**ALERT SERVICE BULLETIN
REVISION NOTICE**

SUBJECT: REVISION "B" TO ALERT SERVICE BULLETIN 222U-04-71:

**TAIL ROTOR BLADE P/N 222-016-001-123, -123M, -131 AND -139M, INSPECTION
AND REWORK OF**

NO. 222U-04-71

Figure 1. Blade Inspection Area

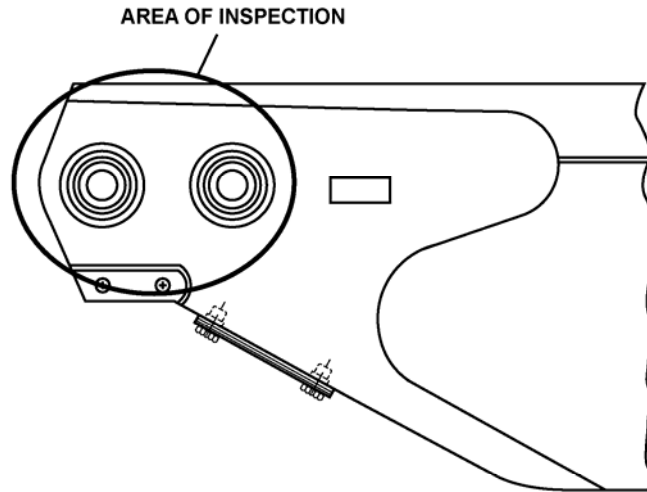
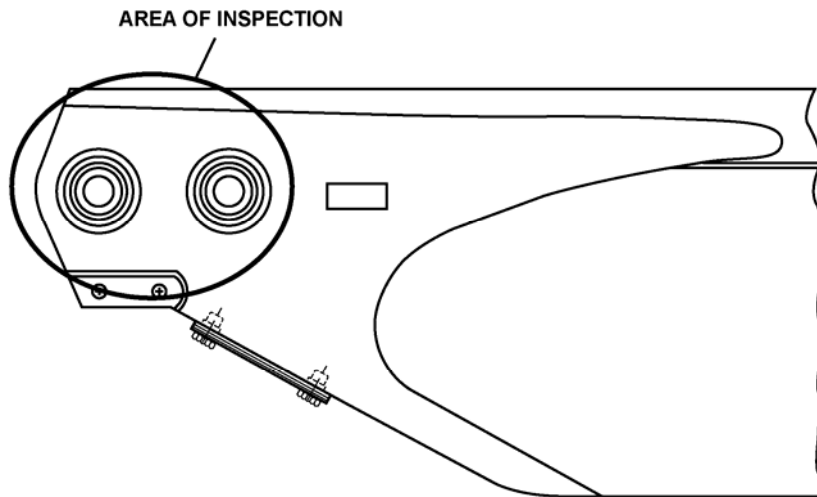
- a. Wipe down both surfaces of each blade around the blade feathering bearings using aliphatic naphtha (C-305) or detergent (C-318) or equivalents. Refer to Figure 1.
 - b. Closely examine the cleaned surface, on both sides of the blade, paying particular attention to the area around both bearings. If no crack is found in the paint, the inspection is complete until next inspection.
 - c. If a crack is found in the paint, maintenance personnel must proceed with step 2.
2. Remove the suspected blade from the helicopter. Refer to BHT-222U-MM-7, Chapter 64.

- a. Wipe down both surfaces of each blade around the blade feathering bearings using aliphatic naphtha (C-305) or detergent (C-318) or equivalents. Refer to Figure 1.
 - b. Using a 10X power magnifying glass, closely examine the cleaned surface, on both sides of the blade, paying particular attention to the area around both bearings.
 - c. If no crack is found in the paint the inspection is complete until next inspection.
 - d. If a crack is found in the paint, proceed with step 2.
2. Remove the tail rotor blade from the helicopter. Refer to BHT-222U-MM-7, Chapter 64.
